# CELEBES SEA, EASTERN PORTION—TALAUTSE ISLES.

No. 312 (first publication).—The following particulars, etc., relative to the above, issued by the British Admiralty (No. 1158 of 1921), are republished:—

*Chart affected.*—No. 3209, Plan of Mampya road.

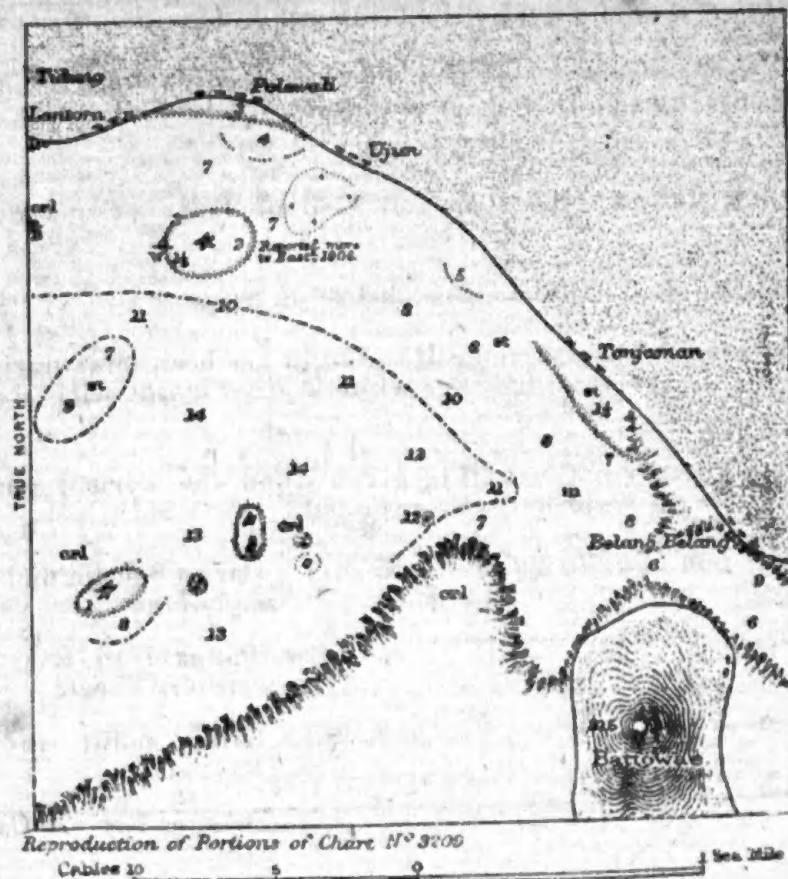
*Details.*—The accompanying reproduction of a portion of the plan of Mampya road on chart No. 3209 shows the necessary corrections to that plan with regard to the existence of reefs.

Reproduction of Portions of Chart No. 7.

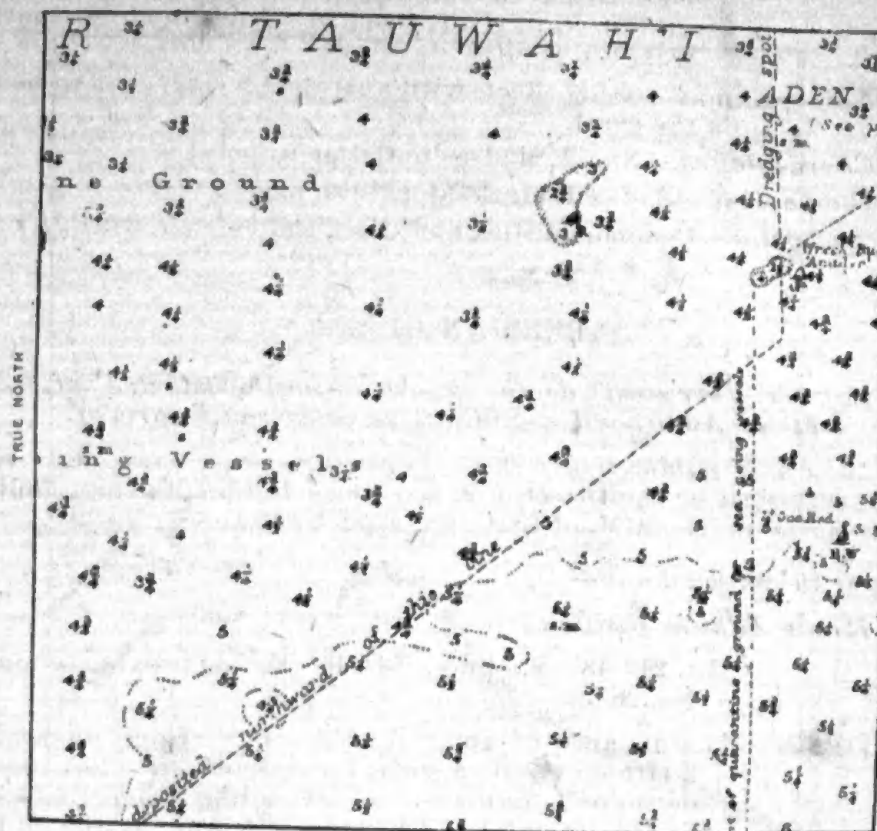
*Remarks.*—The 5 fathom line appears to be approximately correct, but 6-fathom soundings shown inside it are misleading.

Reproduction of Portions of plan on Chart No. 684.

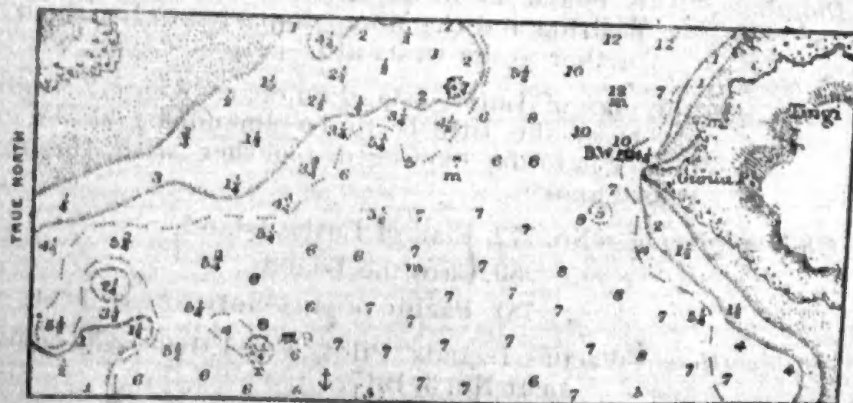
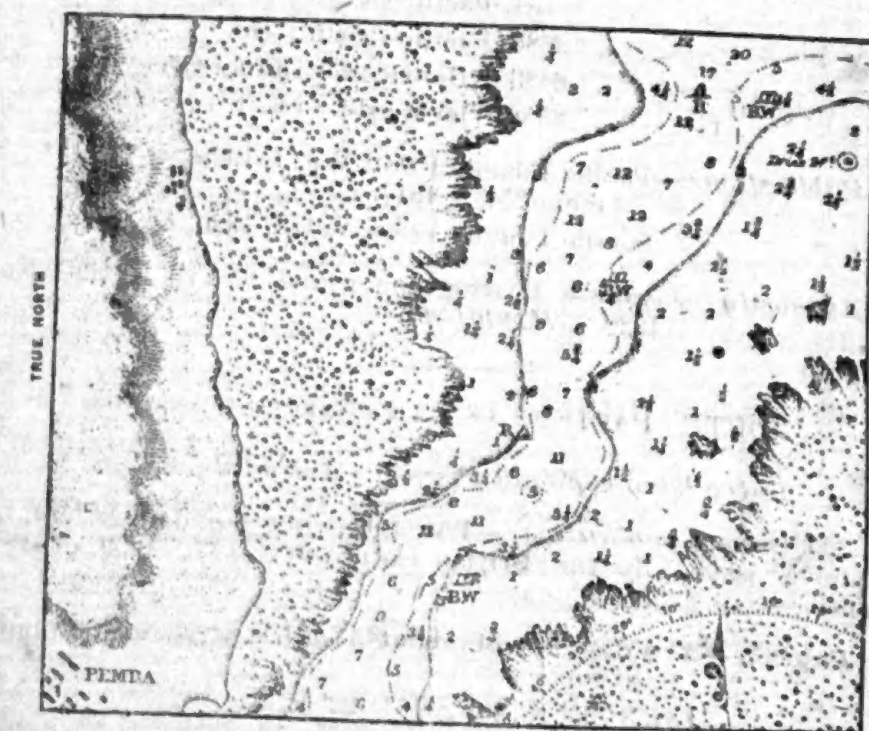
*Details.*—The accompanying reproduction of two portions of the plan of Mikindani harbour entrance on chart No. 684 shows the necessary corrections to that plan with regard to buoyage.

Reproduction of Portion of Chart No. 1725

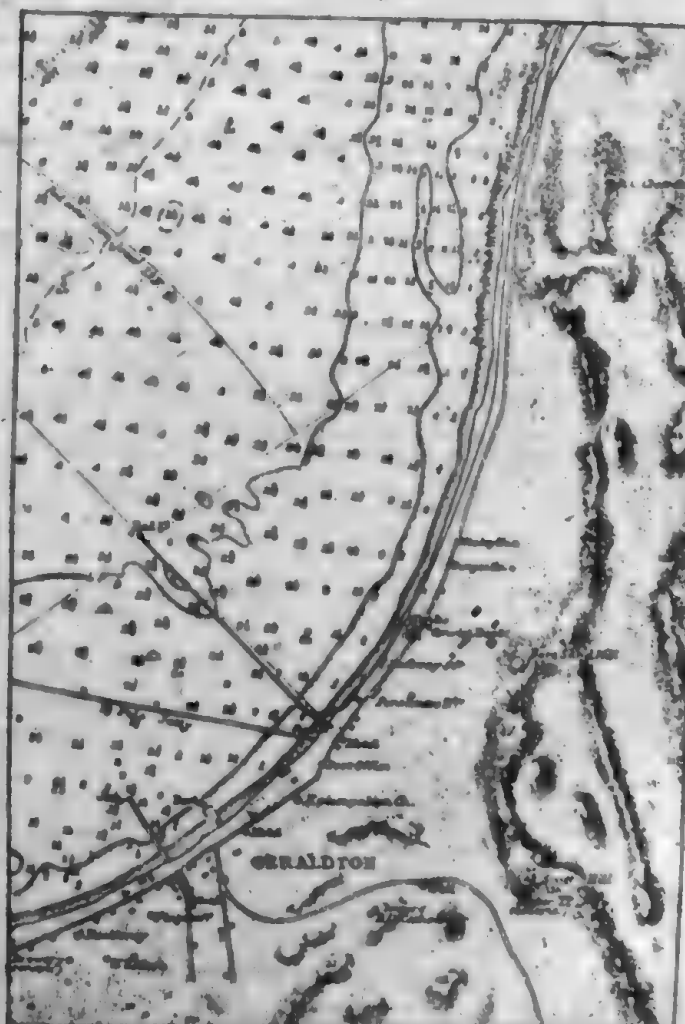
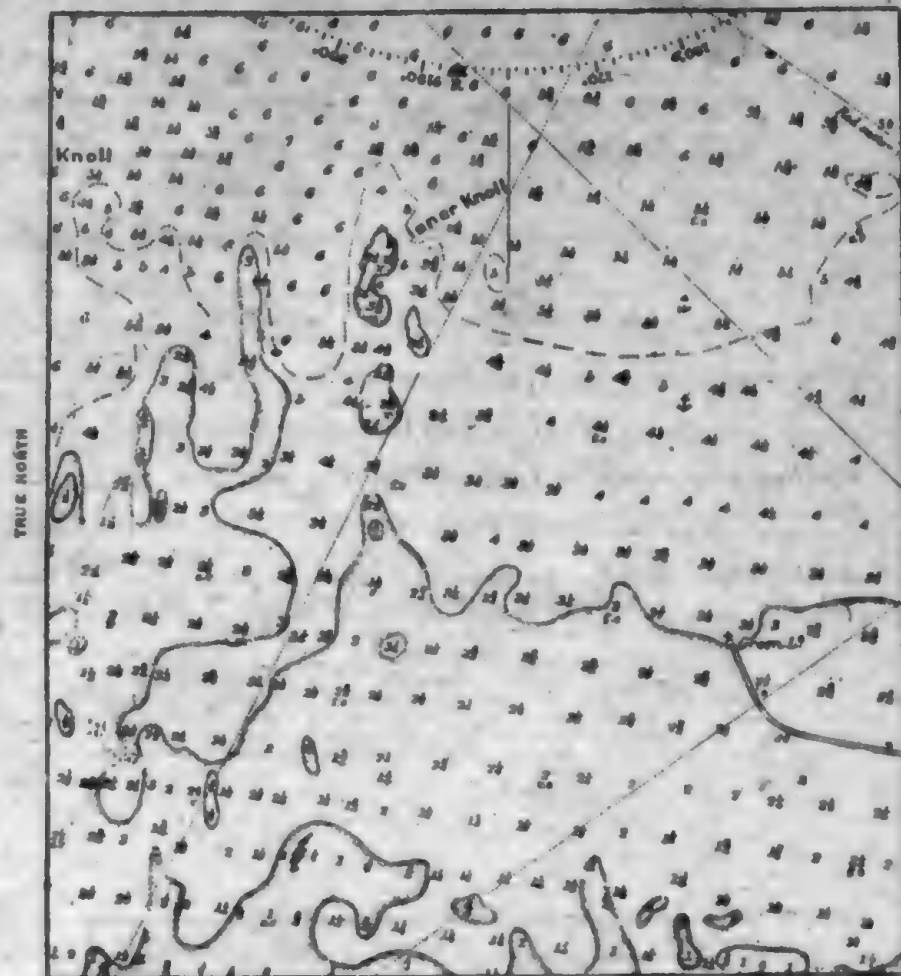
*Details.*—The accompanying reproductions of portions of charts Nos. 1725 and 1723 show the following:—

- (a) Amendments to charts with regard to shoals.
- (b) Extension of the North jetty and amended position of front leading light.
- (c) New pile jetty completed, from which a *green* light is exhibited.
- (d) Position of certain landmarks.

*Chart affected.*—No. 3209, Plan of Mampya road.

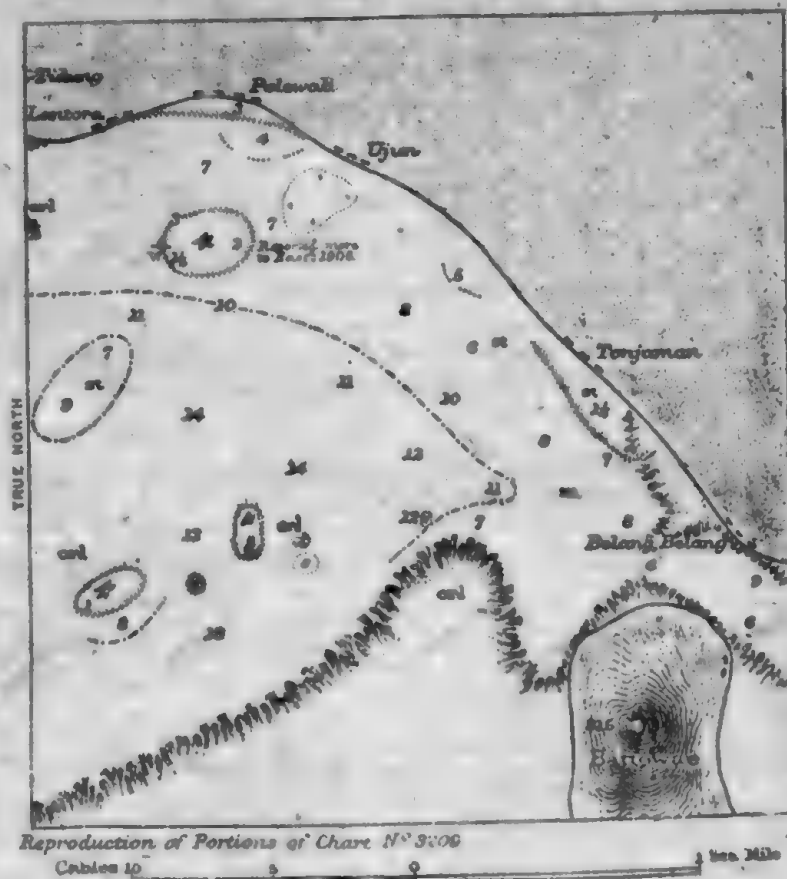
*Details.*—The accompanying reproduction of a portion of the plan of Mampya road on chart No. 3209 shows the necessary corrections to that plan with regard to the existence of reefs.

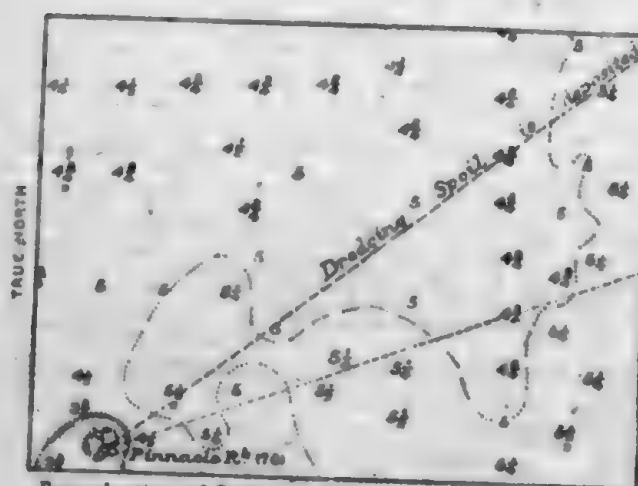
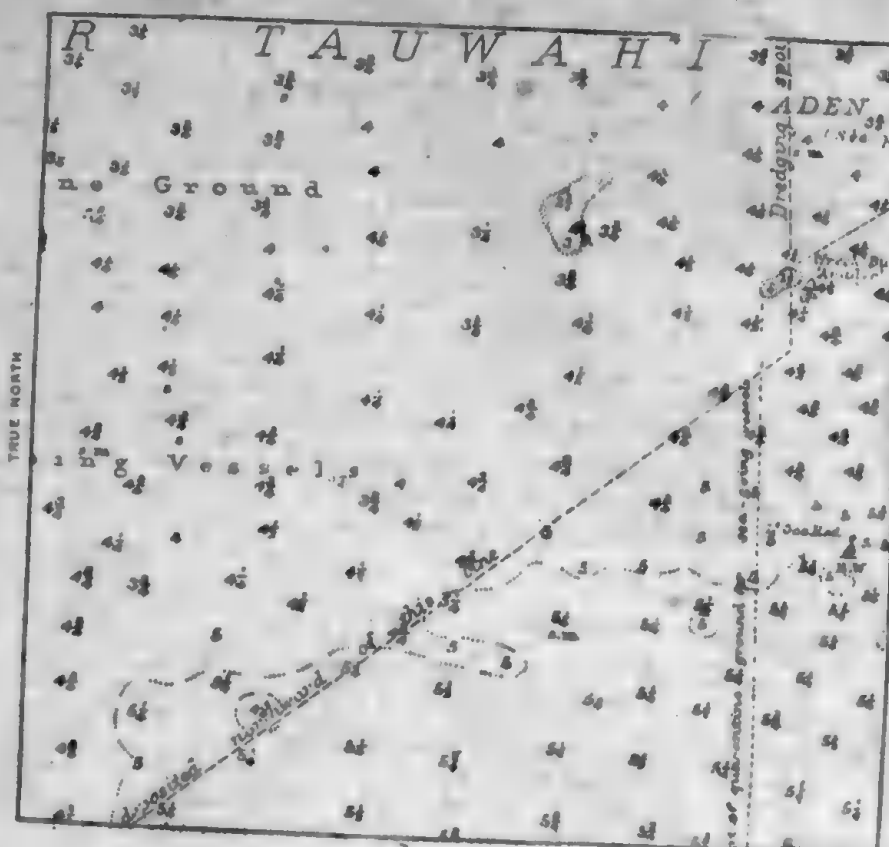
*Details.*—The accompanying reproduction of portions of chart No. 7 shows the necessary corrections with regard to decreased depths in the outer harbour at Aden.

*Remarks.*—It is intended to mark the  $4\frac{1}{2}$ -fathom ( $7\text{m}8$ ) patch, situated about  $1\frac{1}{2}$  miles north-eastward of Pinnacle rock, by a black can-buoy, concerning which further Notice will be given.

Reproduction of Portions of plan on Chart No. 684.

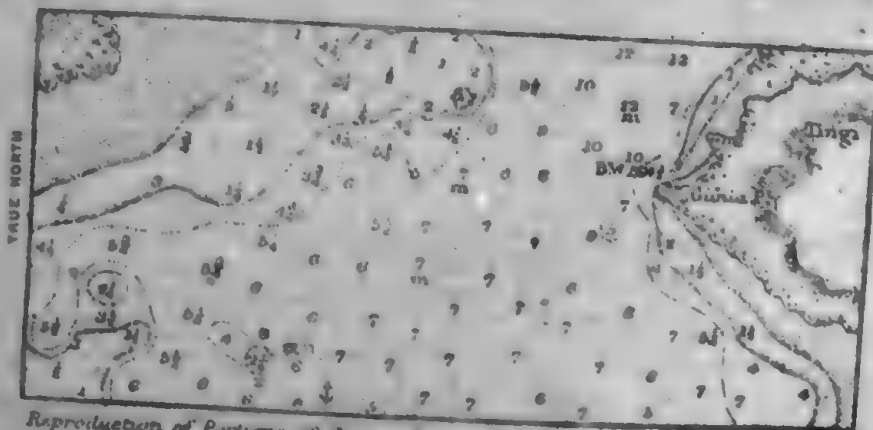
*Details.*—The accompanying reproduction of two portions of the plan of Mikindani harbour entrance on chart No. 684 shows the necessary corrections to that plan with regard to buoyage.

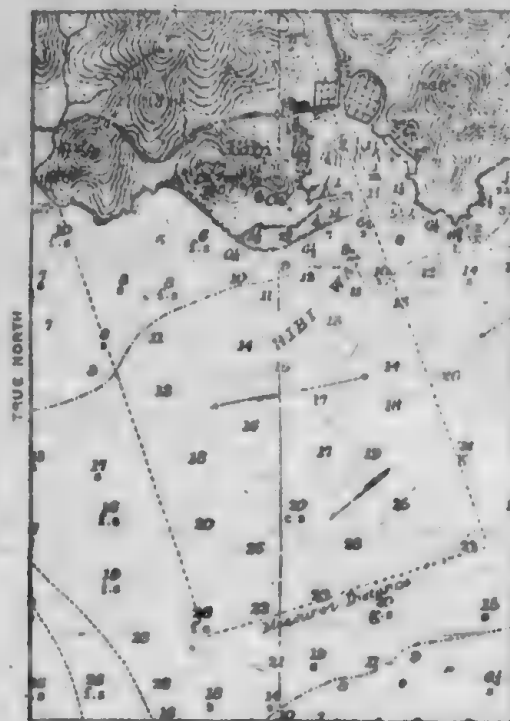
*Details.*—The harbour works at Hibi wan have now been completed and a measured distance, indicated by beacons, has been established as shown on the accompanying reproduction of portions of charts Nos. 1969 and 128.

*Chart affected.*—No. 3209, Plan of Mampya road.

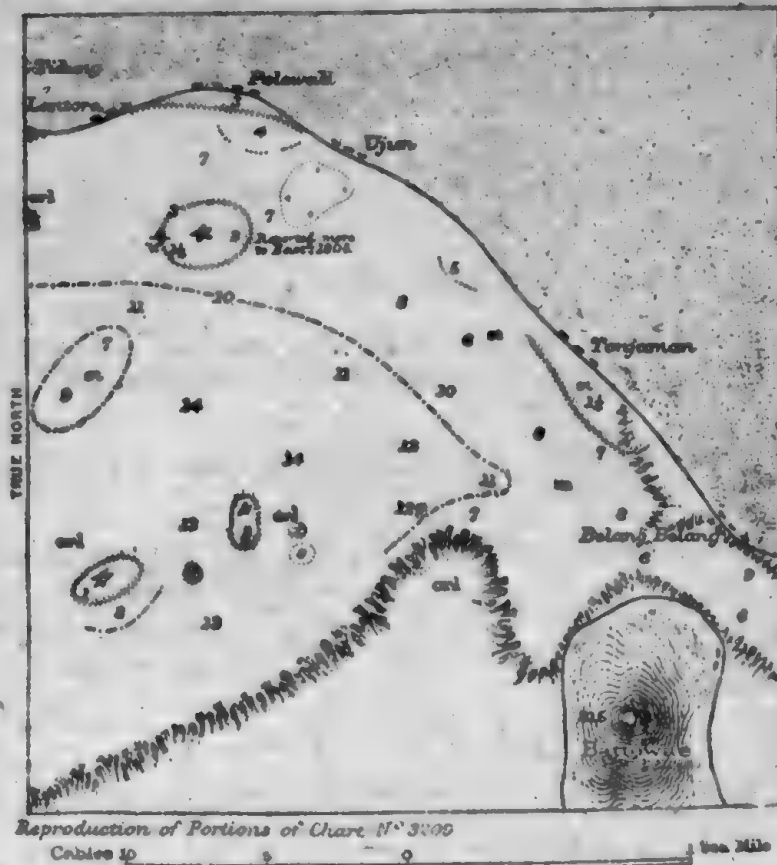
*Details.*—The accompanying reproduction of a portion of the plan of Mampya road on chart No. 3209 shows the necessary corrections to that plan with regard to the existence of reefs.

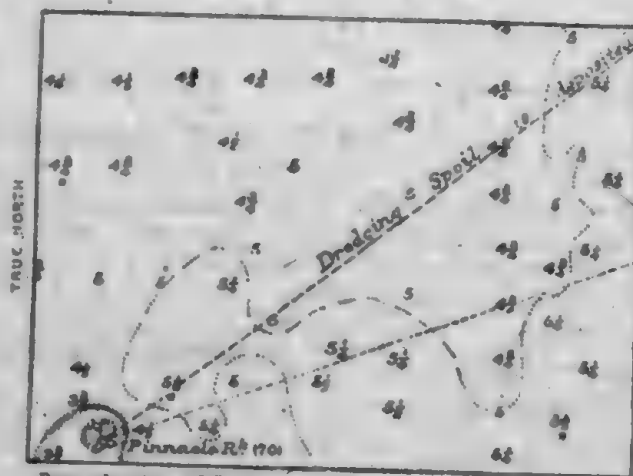
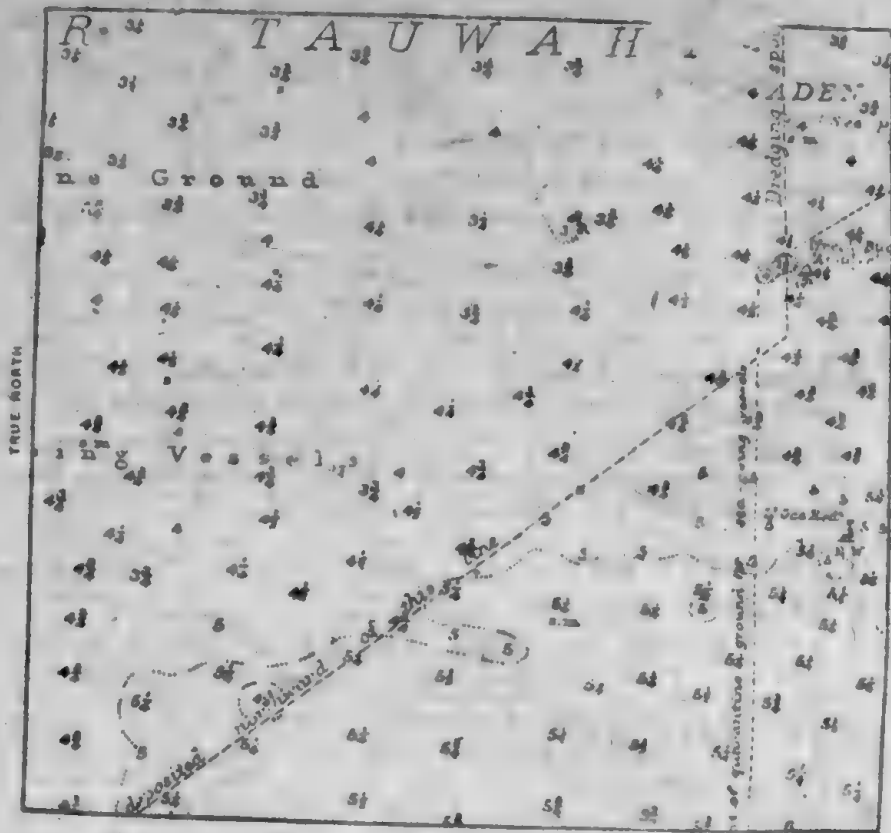
*Details.*—The accompanying reproduction of portions of chart No. 7 shows the necessary corrections with regard to decreased depths in the outer harbour at Aden.

*Remarks.*—It is intended to mark the 4½-fathom (7m8) patch, situated about 1½ miles north-eastward of Pinnacle rock, by a black can buoy, concerning which further Notice will be given.

*Chart affected.*—No. 1460, Plan of Dilhi harbour.

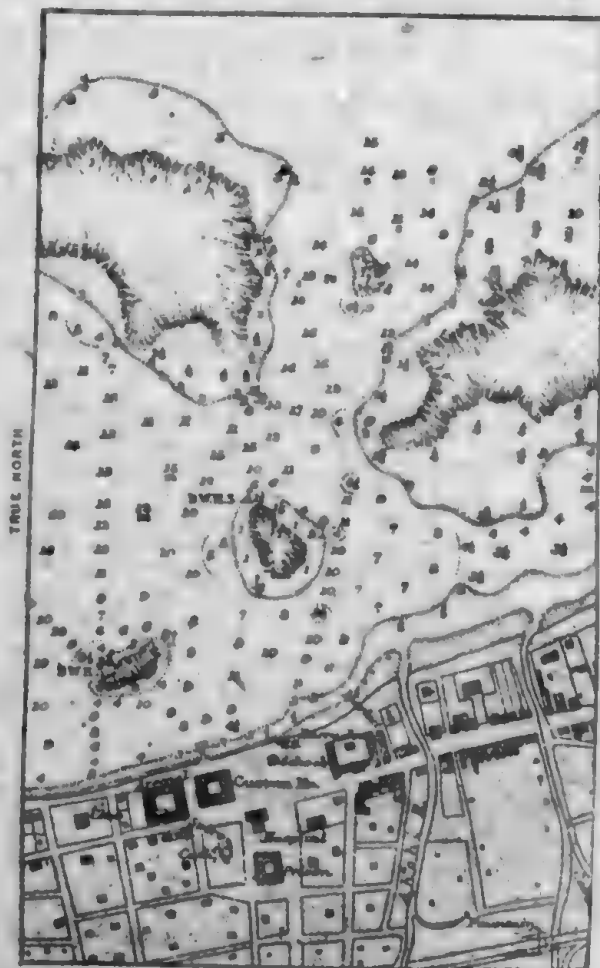
*Details.*—The accompanying reproduction of a portion of the plan of Dilhi harbour on chart No. 1460 shows the necessary corrections to that plan with regard to the positions of buoys and beacons; the positions given are approximate and a note to this effect is to be inserted under the title of the plan.
